## &lt;Addendum #2&gt;

**Date: August 29, 2012**

**PROJECT #: EL-0006-C01**

**DESCRIPTION: Elizabeth Academic High School**

**SI-101**

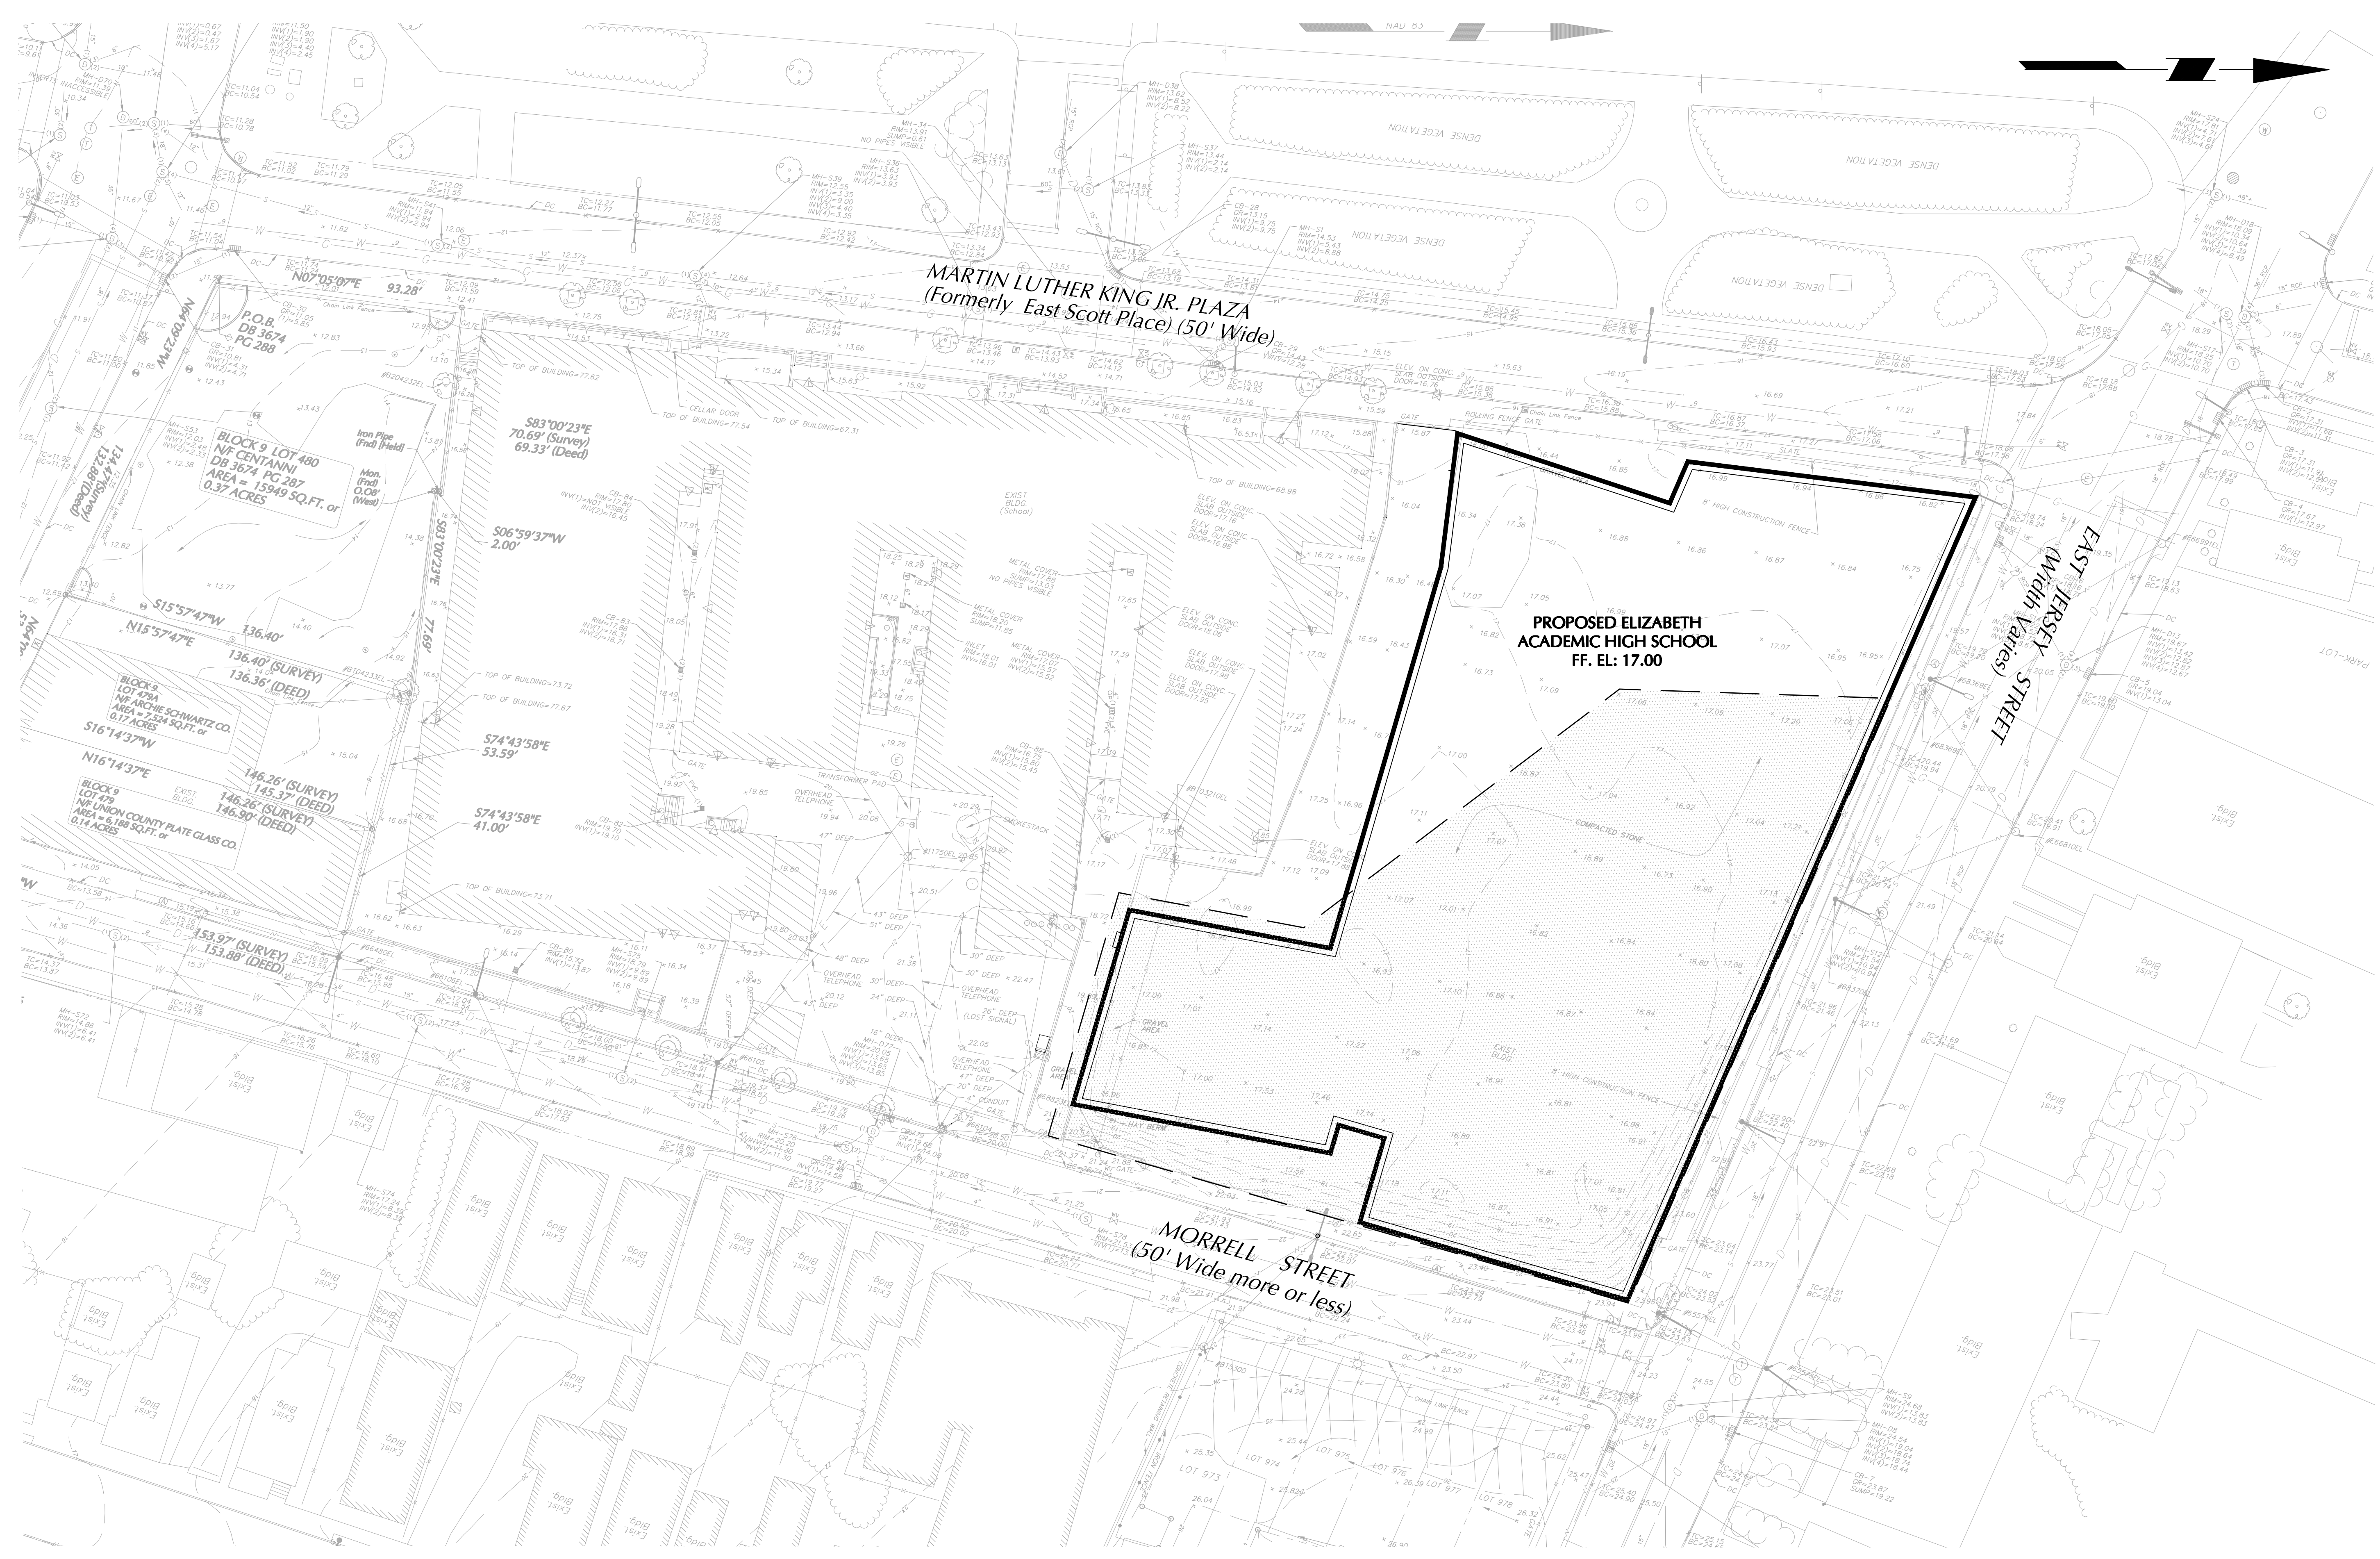
### **B.3**   **Drawing SI-101**

Attachment #3 - Drawing SI-101, titled “Existing Conditions and Foundation Preparation Plan”

- 8. Limits of Soil Excavation and Replacement: Approximate limits of unsuitable soils beneath the design elevations, is shown on drawing SI-101. In his bid, Contractor shall include improvement (excavation, removal and replacement with approved materials) of the unsuitable soils.
